| <p>AT LOWER ROSWELL SUBDIVISION 3140 LOWER ROSWELL ROAD MARISTA, GEORGIA 30088 LAND LOT 1628, 16TH DISTRICT 2ND, SECTION, COBB COUNTY, GEORGIA</p> | | <p>NEW SITE PLAN</p> |  | <p>OWNER/DEVELOPER A P HUGHES, INC. 1375 MARISTA DRIVE MARISTA, GA 30088 PH: 770-988-1000</p> | <p>REVISIONS DATE</p> | <p>20-2-1 2015</p> |

PETITION NO: Z-10

ZONING COMMENTS:

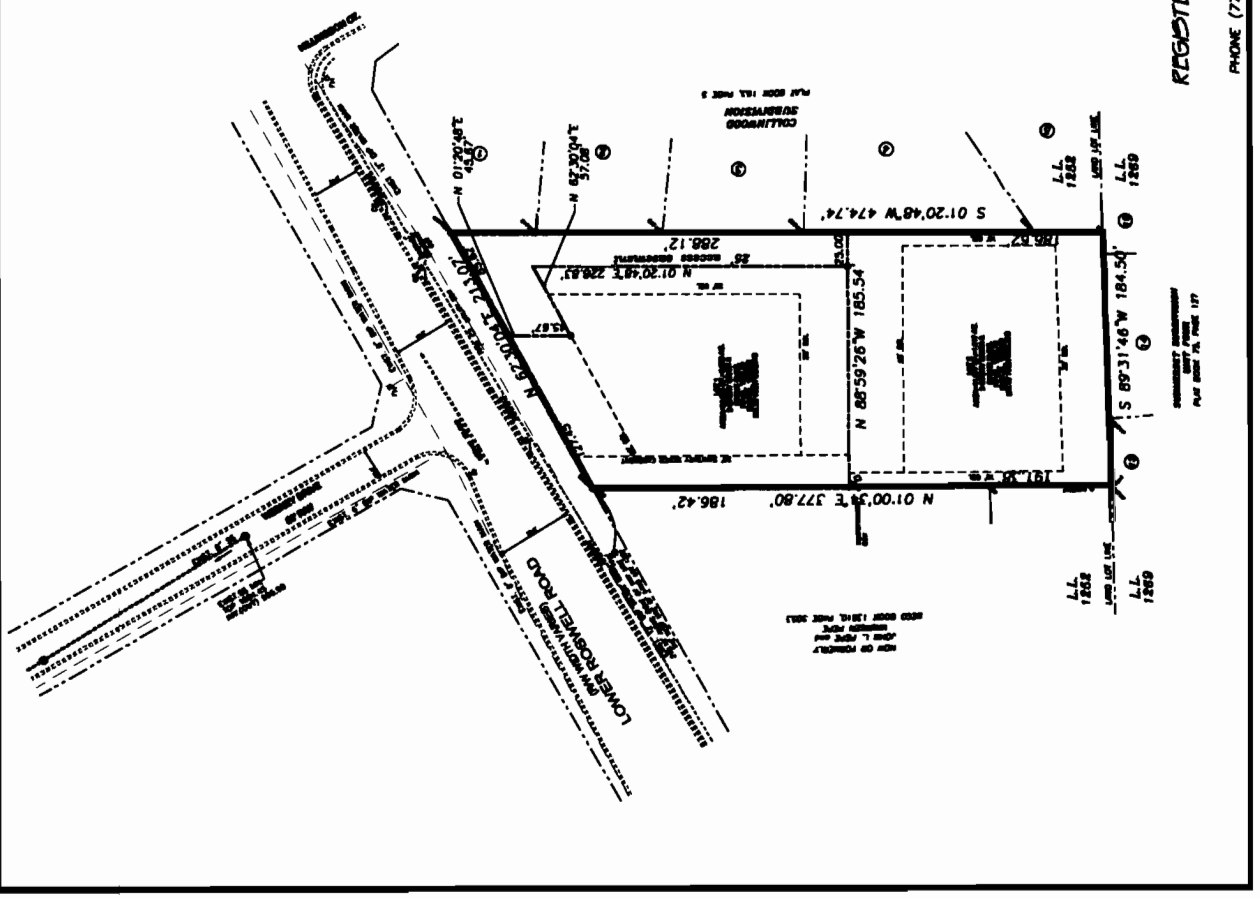
1. Driveway must have a minimum 12' driving surface width with minimum 25' inside turning radius.
2. Fully developed landscaping shall be at least 7'0" from center of drive (14' clear width) and 13'6" vertical clearance. (Indicate on plan minimum setbacks).
3. Maximum grade shall not exceed 18%.
4. Driveway must extend within 150' of the most remote portion of the structure.
5. Driveway is limited to 1000' maximum from roadway unless an approved turn-around is provided. (See note below.)
6. Driveway must support 25 Tons (50,000 lbs.)
7. Provide emergency access to all gates securing Fire Dept. access with a minimum 12'-0" clear width
8. Hydrant within 500' of remote structure, minimum 6" main*
(Required Flow: 1000 gpm @ 20 psi)
9. Fire Flow Test from closest existing hydrant*
(Required Flow: 1000 gpm @ 20 psi)

- No Stormwater controls shown _____
- Copy of survey is not current – Additional comments may be forthcoming when current site conditions are exposed.
- No site improvements showing on exhibit.

1. Lot grading plans must be approved by Stormwater Management Division prior to issuance of building permits. Although there is a recorded drainage easement along the rear of this parcel within the Somerset Subdivision, there is no well-defined conveyance and existing drainage issues. Lot 2 will require the installation of dry wells to reduce the potential impact of any concentrated runoff to the south into the adjacent lots within Somerset Subdivision.

Recommend one shared driveway for both tracts.
